REVISION	DATE	DESCRIPTION	BY
3	Jul 90	As built - No change	D.S.
4	13 May 88	Added Interceptor Ditch No. 1	T.D.
DEPARTMENT OF THE ARMY NEW YORK DISTRICT, CORPS OF ENGINEERS NEW YORK, NEW YORK			
DRAWN BY: <i>EJM</i>		SAW MILL RIVER, NEW YORK	
CHECKED BY: <i>D.S.</i>		ARDSLEY FLOOD CONTROL PROJECT	
DESIGNED BY: <i>Thomas J. ...</i>		MAIN CHANNEL PROFILE	
REVIEWED BY: <i>James ...</i>		ARDSLEY	
SUBMITTED: <i>C. ...</i>		RECOMMENDED: <i>Stanley ...</i>	
APPROVED: <i>W. ...</i>		SCALE AS SHOWN	
DATE: 20 JULY 1987		DRAWING NUMBER: CC-ARD-411	
		SHEET 11 OF 48

Designed by: 	SAW MILL RIVER, NEW YORK
Drawn by: EJM	ARDSLEY FLOOD CONTROL PROJECT
Checked by: D.S.	PROFILES-INTERCEPTOR
	DITCHES NO. 1 & 2
Reviewed by: 	ARDSLEY CHIEF, ENGINEERING DIVISION
Approved by: 	Sheet reference number: CC-ARD-413
Concurred by: 	Date: 20 JULY 1987
ASST. CHIEF, DESIGN BRANCH	Scale: AS SHOWN
	Sheet 13 of 44

SAW MILL RIVER, NEW YORK
ARDSLEY FLOOD CONTROL PROJECT
CROSS SECTIONS—STA 0+27U TO STA 8+02U

A

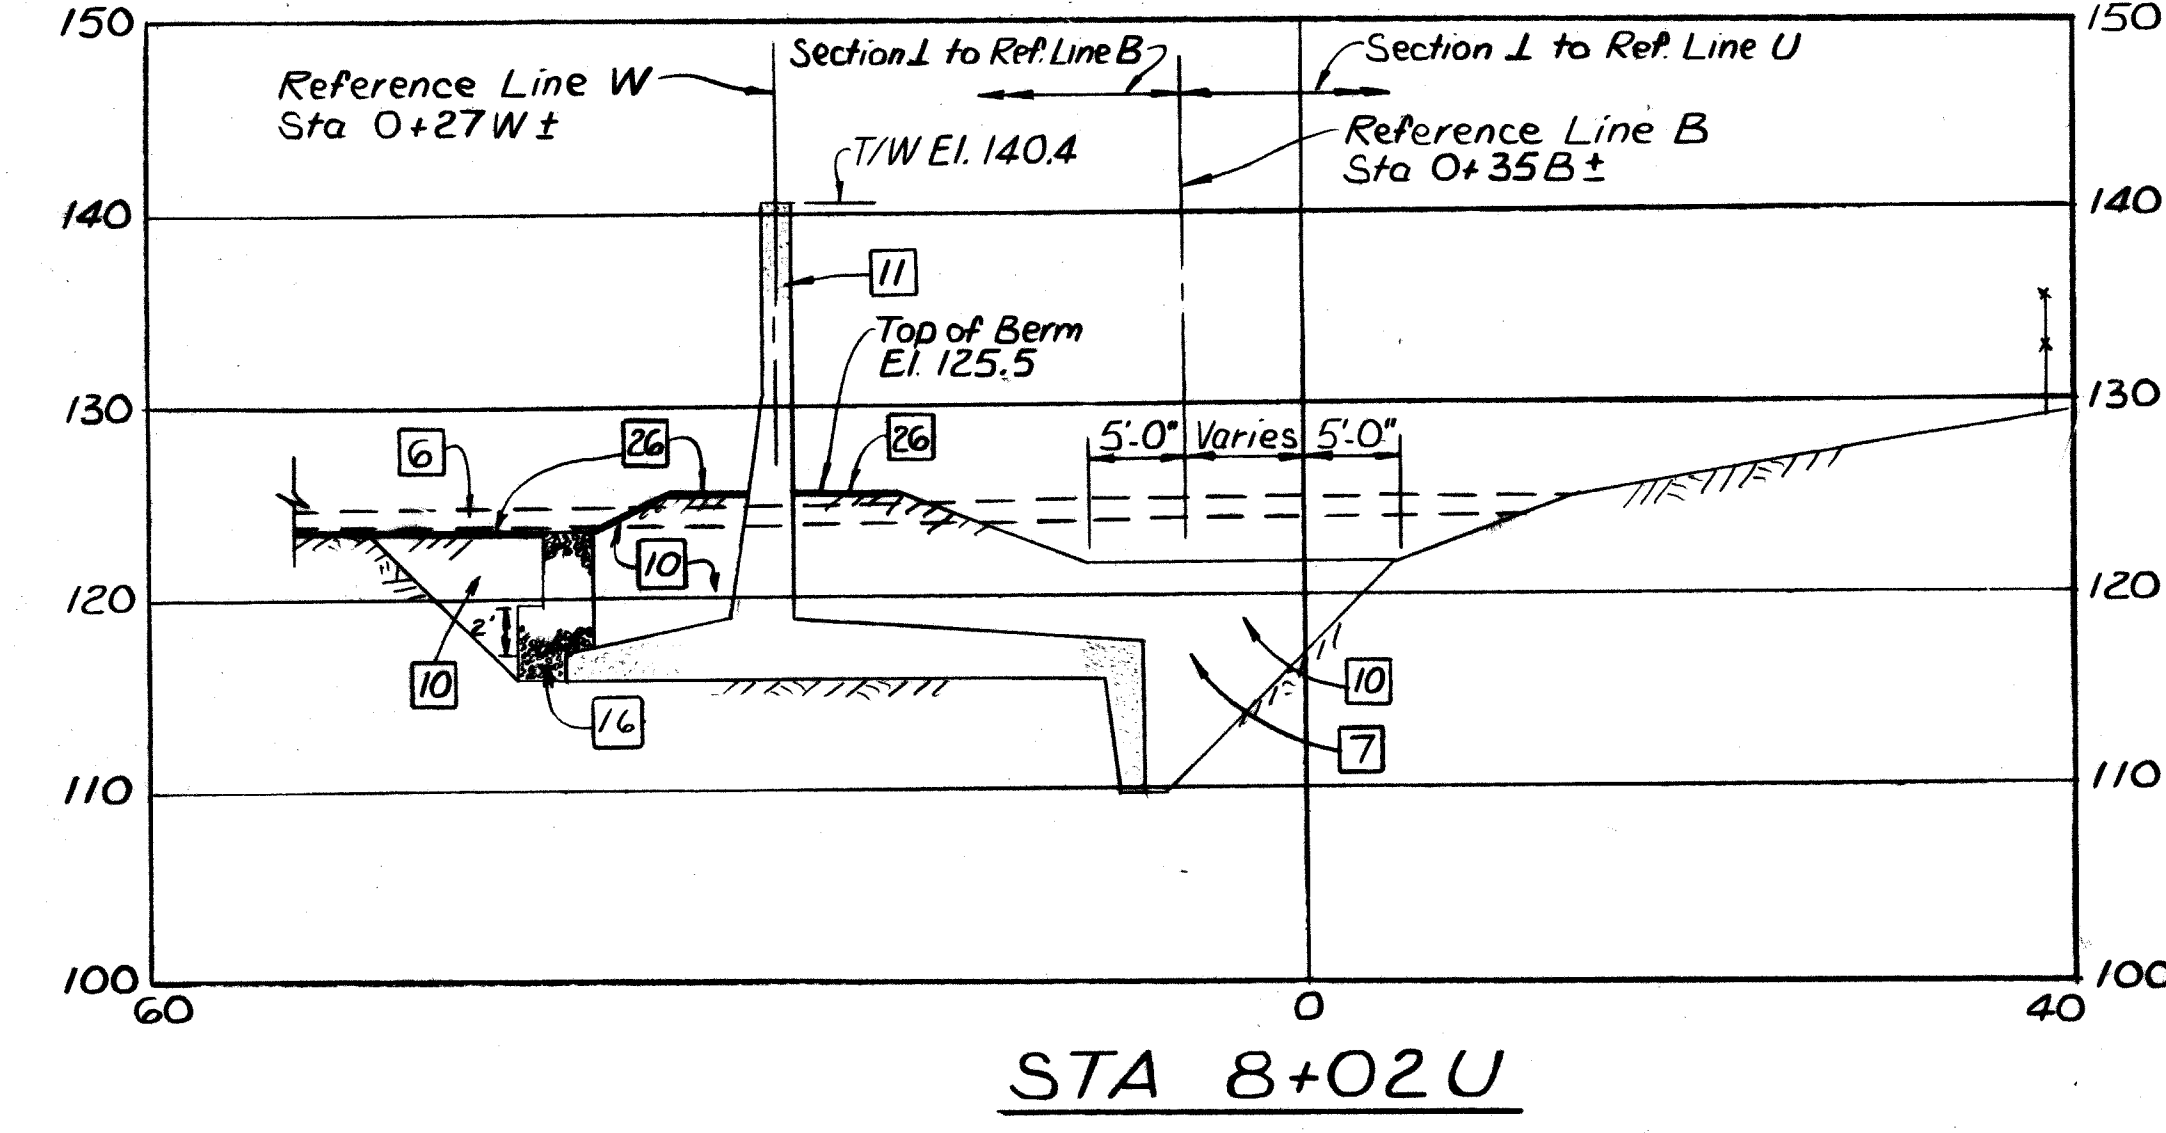
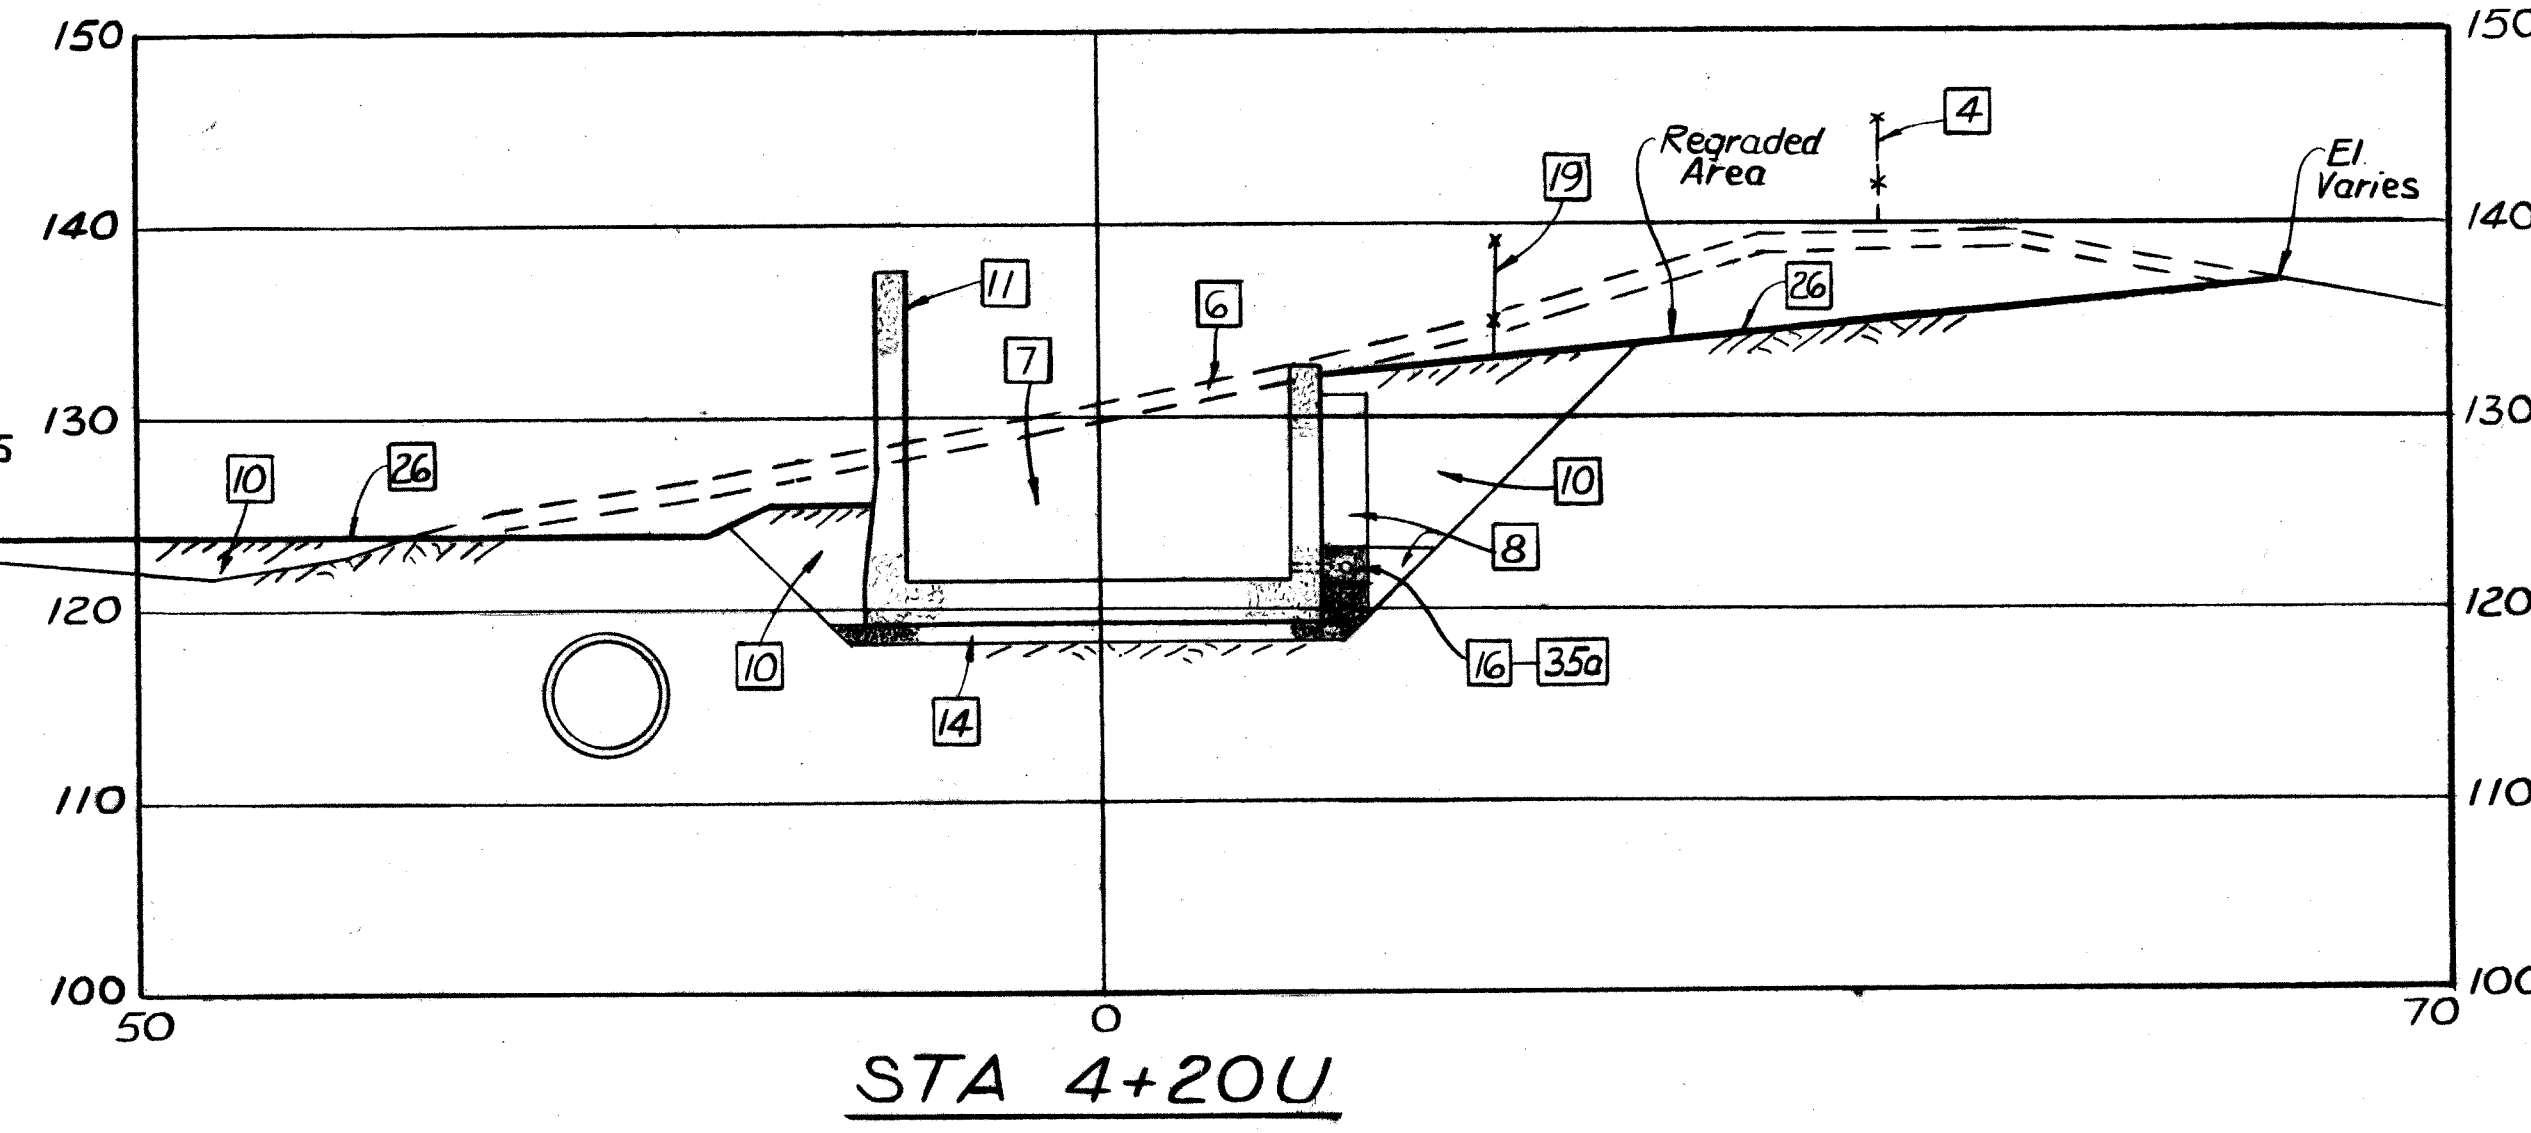
Revision	Description	Date	Approved
1	curtain walls replaced by piles - as built	4/14/90	O.P.
2	Revised Fence Location STA 2+18U, STA 3+17U	13 May 98	T.D.

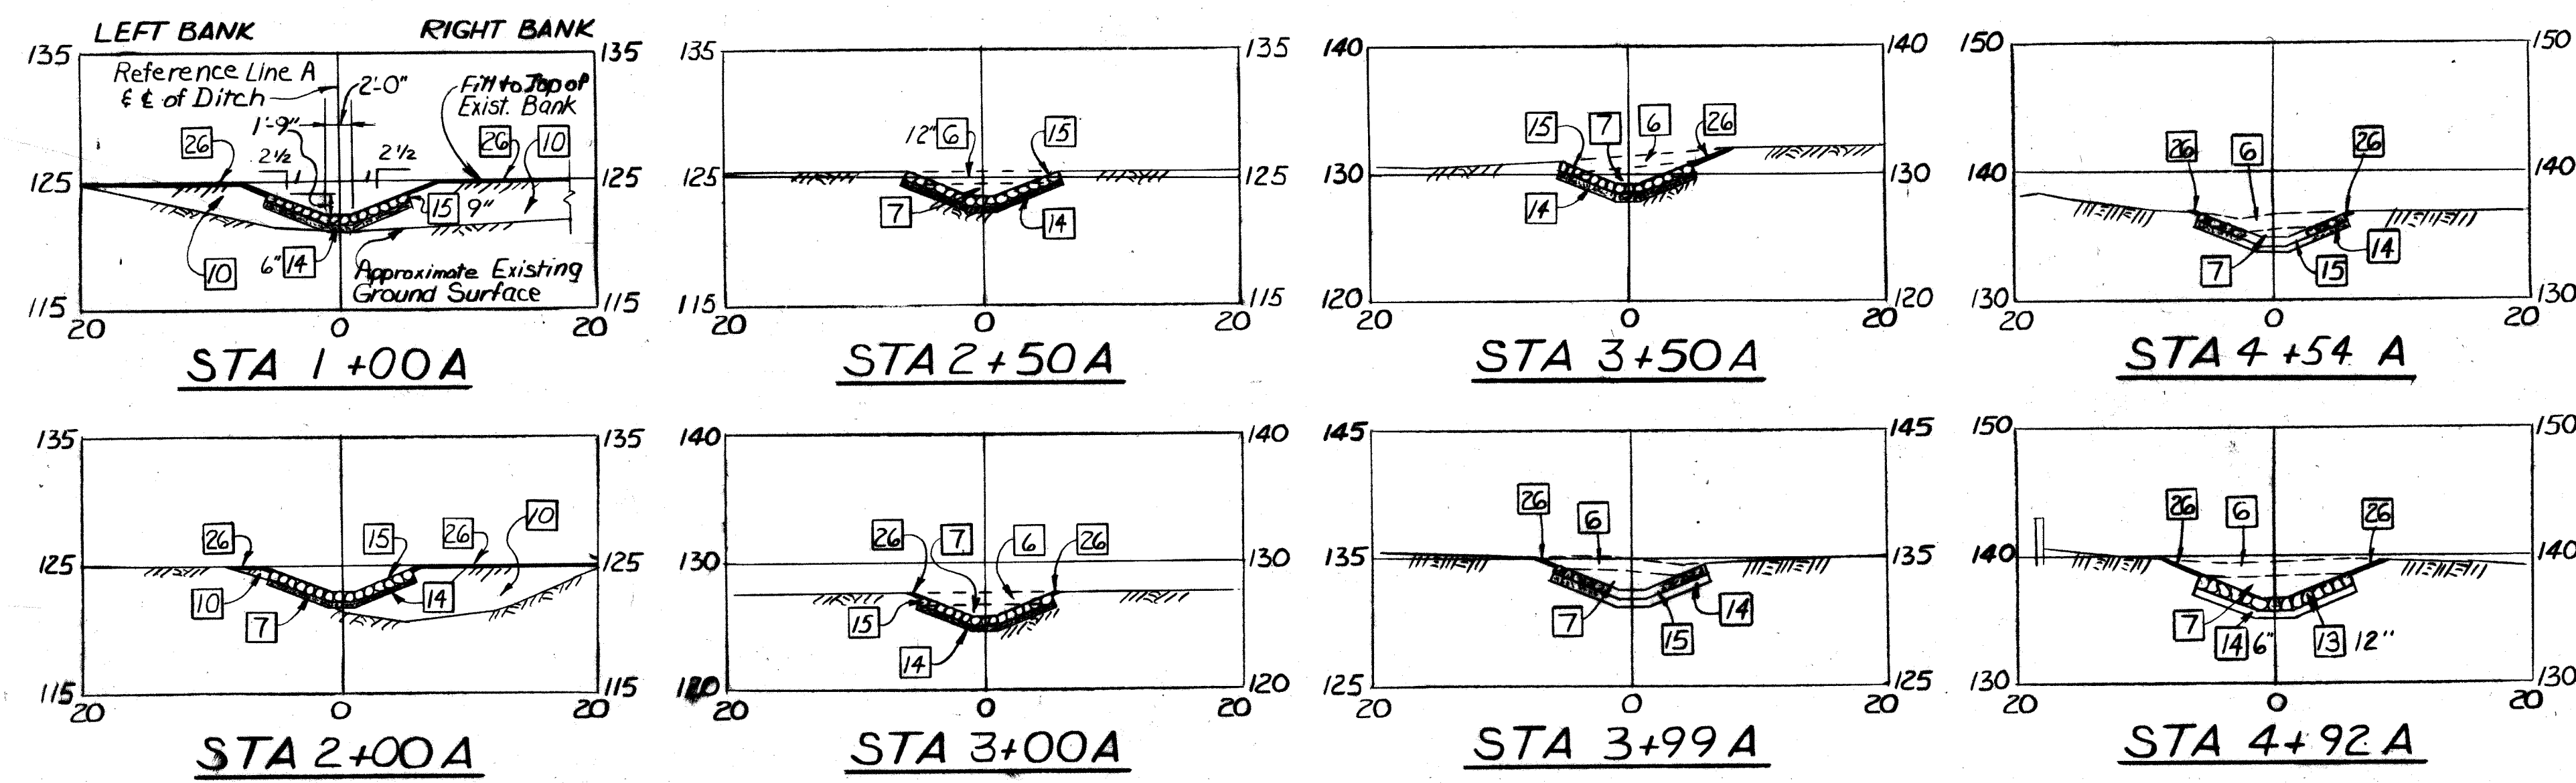
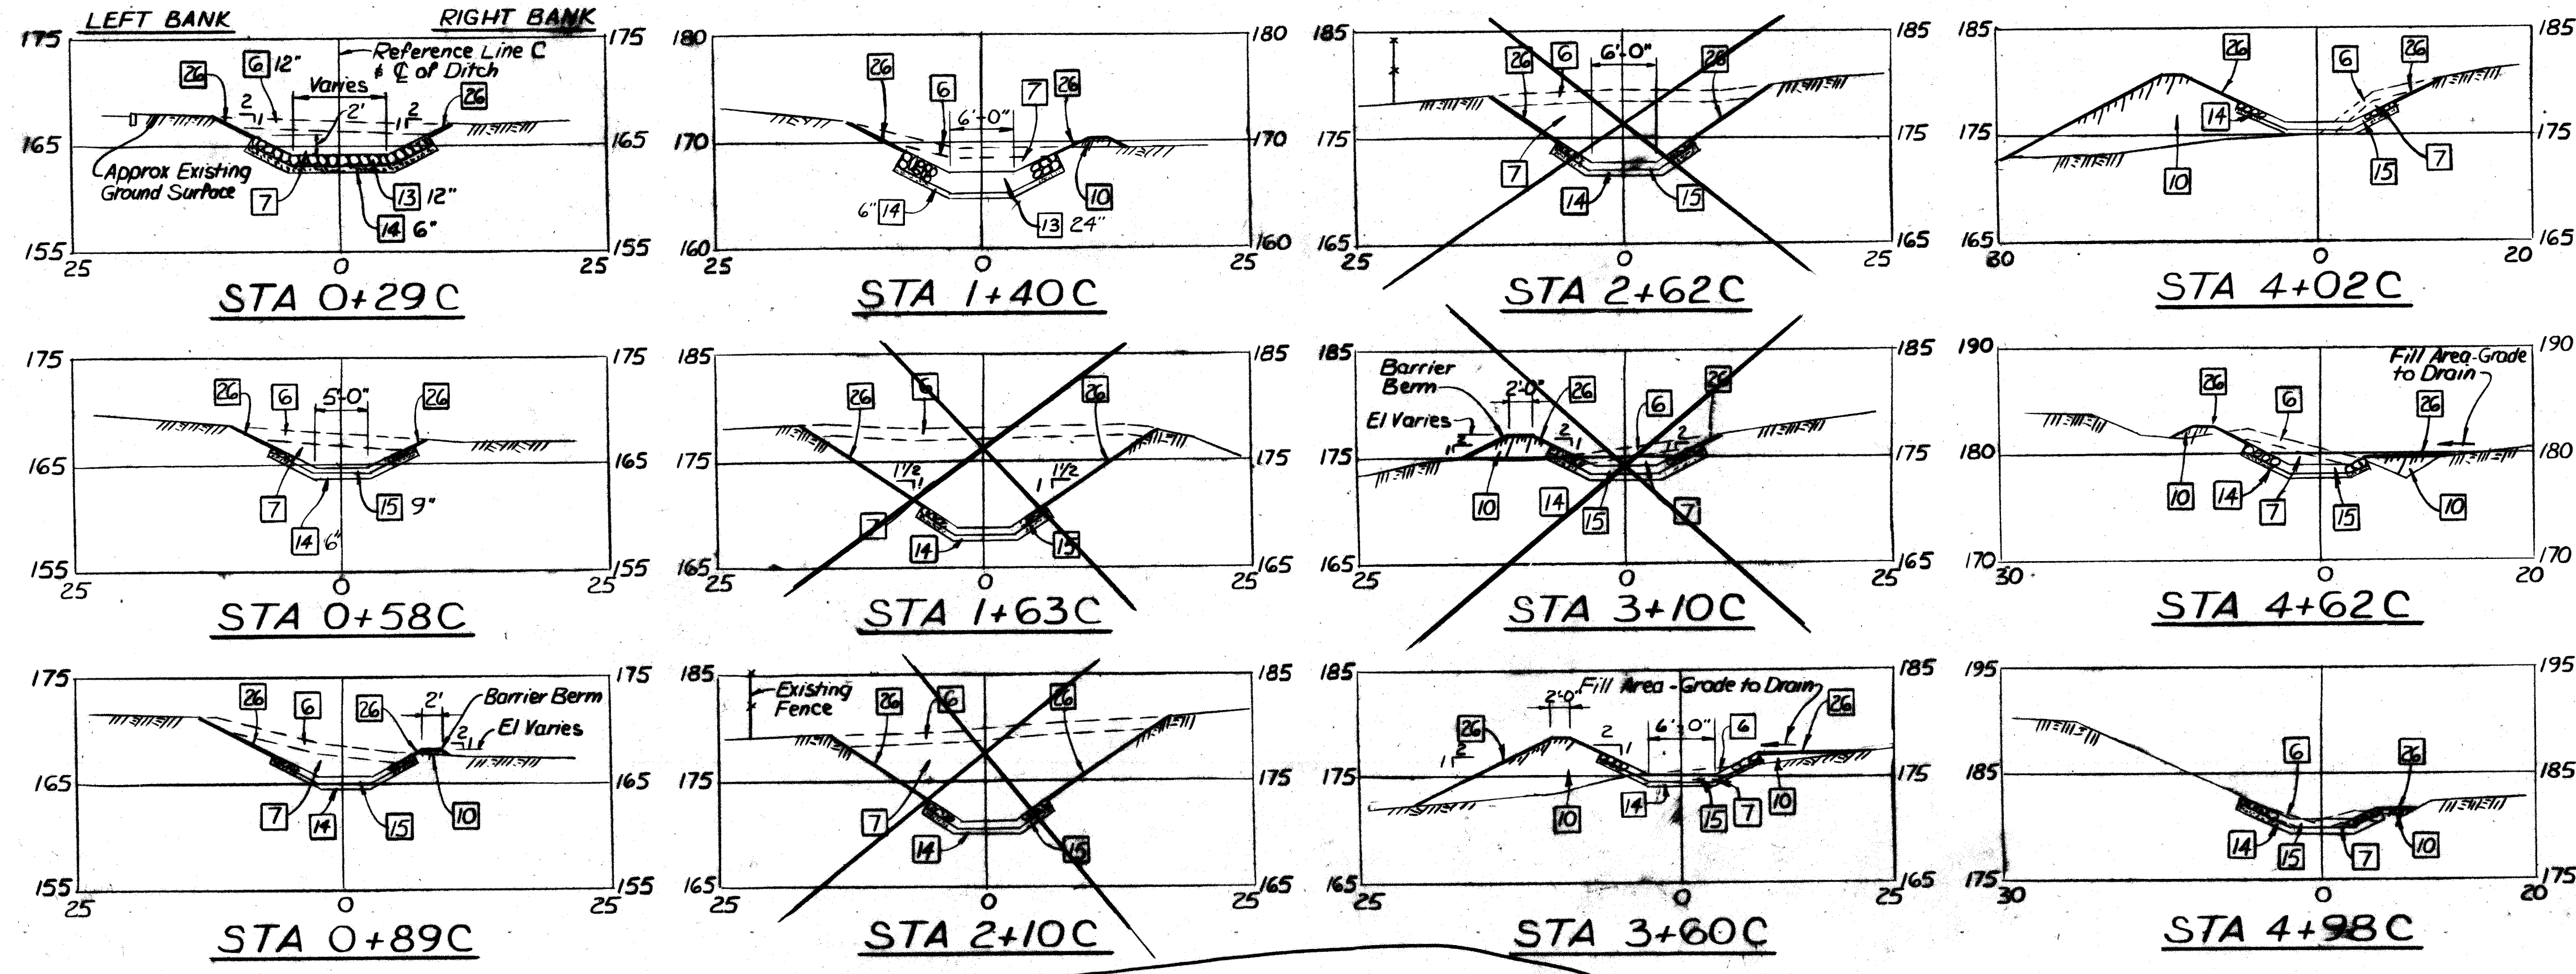
As Built - No change		3/Jul/90	D.S.
Revised Interceptor Ditch No 2		5/May/89	T.D.
Revised Interceptor Ditch No 1		13/May/88	T.D.
Revision	Description	Date	Approved
U.S. ARMY ENGINEER DISTRICT CORPS OF ENGINEERS NEW YORK, NEW YORK			
SAWMILL RIVER, NEW YORK			
ARDSLEY FLOOD CONTROL PROJECT CROSS SECTIONS PONDING AREAS NO. 1 & 2 INTERCEPTOR DITCHES NO. 1 & 2			
Designed by:	SAWMILL RIVER, NEW YORK		
Drawn by:	ARDSLEY FLOOD CONTROL PROJECT		
Checked by:	CROSS SECTIONS		
Reviewed by:	PONDING AREAS NO. 1 & 2		
Approval Recommended:	INTERCEPTOR DITCHES NO. 1 & 2		
Section Chief:	Sheet reference number:	Date:	20 JULY 1987
Approved by:	CC-ARD-416	Scale:	AS SHOWN
Asst. Chief, Design Division:	Sheet 16 of 44
